Access Compliance Report

Public Rights-of-Way

(Curb Ramps)

Intersection ID: 49321	Main Street: WHITEBEAM_WY	Cross Street: HUNTERS_MOON_LN	Location: NE
ADA ID: 3016068D1B67	Ramp Type: PerpDiag	Initial Pass/Fail: Pass	Overall Compliance: No
		Severity Score: 0

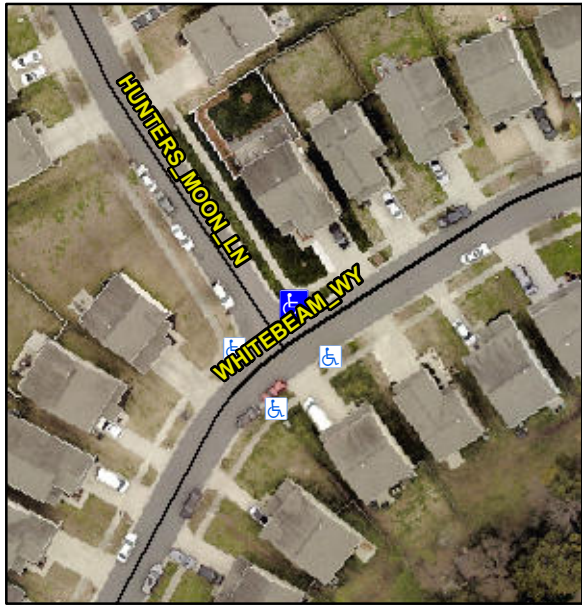
Codes/Mitigation Info/Possible Solution			Field Measurements/Component Compliance					
 Street 1 Name HUNTERS MOON LN Stop Condition-Street 2 StopSign Street 2 Name WHITEBEAM WY Stop Condition-Street 1 None	Possible Solutions:		Compliance			Compliance		
	Remove & Replace Curb Ramp With Two New Directional Ramps or Equivalent.		Description			Data		
	Surveyor Notes: N/A		N/A	Ramp Length (in)	70.0	Yes	Ramp Slope (%)	6.9
			Yes	Ramp Width (in)	48.0	Yes	Ramp XSlope (%)	1.1
			N/A	Flare Type LT	Sloped	N/A	Flare Type RT	N/A
			N/A	Flare Slope LT (%)	6.2	Yes	Flare Slope RT (%)	1.8
			N/A	Flare Traversable LT?	Yes	N/A	Flare Traversable RT?	Yes
			No	Landing Length (in)	40.0	Yes	DWS Provided?	Yes
			Yes	Landing Width (in)	48.0	Yes	DWS Contrast?	Yes
			Yes	Landing Slope (%)	1.0	Yes	DWS Length (in)	24.0
			Yes	Landing X Slope (%)	1.4	Yes	DWS Full Width?	Yes
			N/A	Landing Curb? (Y/N)	No	No	DWS Offset (in)	3.0
			N/A	Shared Landing?	No

Yes	Gutter Ponding?	No	Yes	Gutter Slope (%)	0.6
			Yes	Gutter Lip Ht (in)	0.0	Yes	Gutter X Slope (%)	0.7
			N/A	Painted X Walk1?	No	N/A	Painted X Walk2?	No
				X Walk 1 Direction	To SW		X Walk 2 Direction	To SE
			N/A	X Walk 1 Width (in)	N/A	N/A	X Walk 2 Width (in)	N/A
				X Walk 1 Slope (%)	5.2		X Walk 2 Slope (%)	2.0
				X Walk 1 X Slope (%)	3.1		X Walk 2 X Slope (%)	5.9
			N/A	Ramp inside XWalk1?	N/A	N/A	Ramp inside XWalk2?	N/A
		Road Slope (%)	0.4	N/A	Clear Space?	Yes		
		Road X Slope (%)	7.0	N/A	Clear Space to XWalk (in)	N/A		
	Yes	Any Obstructions?	No	Yes	Storm Grate/Utility Hazard?	No		
		Obstruction Type			Storm Grate/Utility Type			
	Total Cost:		\$	3200.00	N/A			N/A
				Yes	Surface Condition? (G/P)	Good
